UNITED STATES PATENT AND TRADEMARK OFFICE

Office Action Summary

09/437,296

DETAILED ACTION

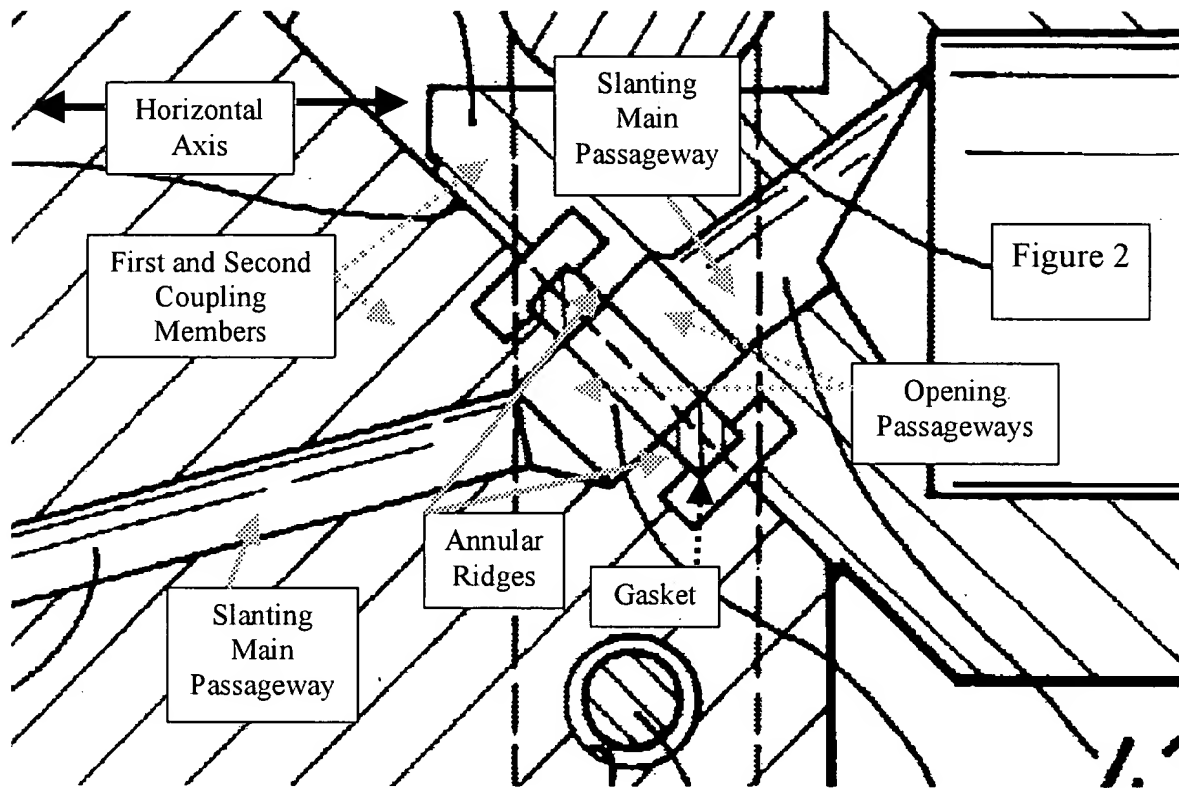
In regards to claim 1, in figure 2 below, as best understood, Nakazawa et al discloses a fluid coupling comprising first and second coupling members having respective gasket holding annular ridges on butting end faces thereof; and

an annular gasket interposed between the first and second coupling members, wherein each coupling member has a fluid channel comprising an opening passageway orthogonal to the butting end face thereof, and a slanting main passageway communicating therewith, the opening passageway having a diameter equal to the inside diameter of the gasket holding annular ridge, and

the gasket holding annular ridges are in contact with the gasket at its radial midportion so as (capable) to relieve the inner peripheral portion of the gasket from stress concentration and wrinkles.

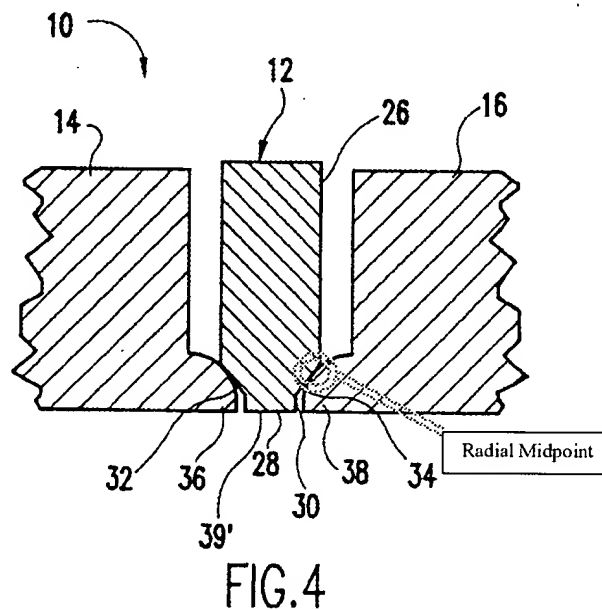
Applicant's arguments filed 12/9/2004 have been fully considered but they are not persuasive. The Applicant argues that in Figure 4 McGarvey fails to show gasket holding ridges which are rounded so as to be in contact with the gasket only at its radial midpoint. The Examiner disagrees.

In Figure 4 above, McGarvey clearly illustrates gasket holding ridges which are rounded so as to be in contact with the gasket only at its radial midpoint.
